Review of cycling infrastructure around the Swiss Cottage Gyratory

Camden Cyclists (by Kaveh Kordestani), July 2025

From Eton Avenue (westbound)*Fig 1.1: shared space from Eton Ave**Fig 1.2: path during market hours*

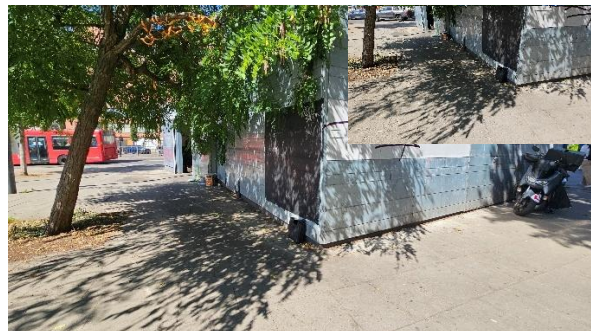
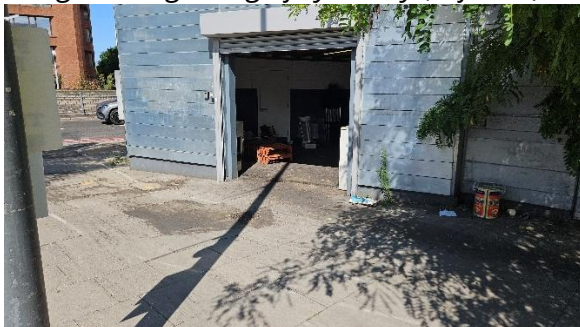
- **1** This is a shared-use space (fig 1.1).
- On Wednesdays there is a farmers' market. Whilst this often leads to obstructed routes for cycles, cycling is still possible (fig 1.2).
- If following the LCN Link, cycles enter this area by coming northwards on Winchester Road and turning left onto Eton Avenue.
- Owing to the moderate pedestrian volumes, this **works effectively**.

*Fig 5.1: bus lane leading to **6***

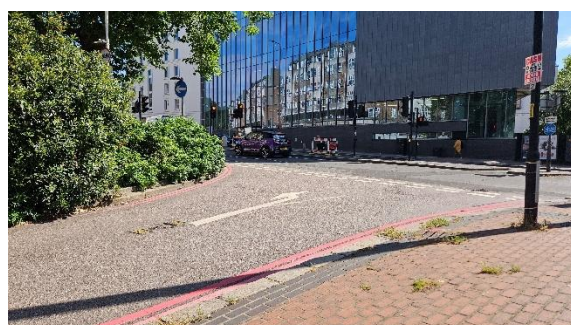
- Beginning at **9**, cyclists must stay in the bus lane to proceed on this route. It is frequently blocked as there is a bus stop at **5** that serves four routes (fig 5.1).
- There is no dedicated left turn lane to enter the area at **6** (fig 5.2). Neither is there any segregation, meaning that cyclists share this small area with double-decker buses.
